## Access Compliance Report Public Rights-of-Way (Curb Ramps)

Intersection ID: 17409 Main Street: HILLSIDE\_AV Cross Street: PARK\_RD Location: SE

ADA ID: 86EE88FB1F28 Ramp Type: Perp Initial Pass/Fail: Fail Overall Compliance: No Severity Score: 18.75

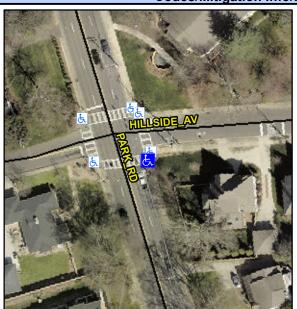
Not Found, R304.5.1, R304.5.3

Field Measurements/Component Compliance						
	Compliance Description		Data	Compliance Description		Data
	N/A	Ramp Length (in)	71.0	Yes	Ramp Slope (%)	6.7
	No	Ramp Width (in)	35.0	No	Ramp XSlope (%)	3.2
	N/A	Flare Type LT	N/A	N/A	Flare Type RT	N/A
	N/A	Flare Slope LT (%)	N/A	N/A	Flare Slope RT (%)	N/A
	N/A	Flare Traversable LT?	N/A	N/A	Flare Traversable RT?	N/A
	N/A	Landing Length (in)	N/A	N/A	DWS Provided?	N/A
	N/A	Landing Width (in)	N/A	N/A	DWS Contrast?	N/A
	N/A	Landing Slope (%)	N/A	N/A	DWS Length (in)	N/A
	N/A	Landing X Slope (%)	N/A	N/A	DWS Full Width?	N/A
	N/A	Landing Curb? (Y/N)	N/A	N/A	DWS Offset (in)	N/A
	N/A	Shared Landing?	N/A			
	N/A	Gutter Ponding?	N/A	N/A	Gutter Slope (%)	N/A
	N/A	Gutter Lip Ht (in)	N/A	N/A	Gutter X Slope (%)	N/A
	N/A	Painted X Walk1?	Yes	N/A	Painted X Walk2?	N/A
		X Walk 1 Direction	To W		X Walk 2 Direction	N/A
	N/A	X Walk 1 Width (in)	106.0	N/A	X Walk 2 Width (in)	N/A
		X Walk 1 Slope (%)	7.2		X Walk 2 Slope (%)	N/A

Remove & Replace Entire Ramp.
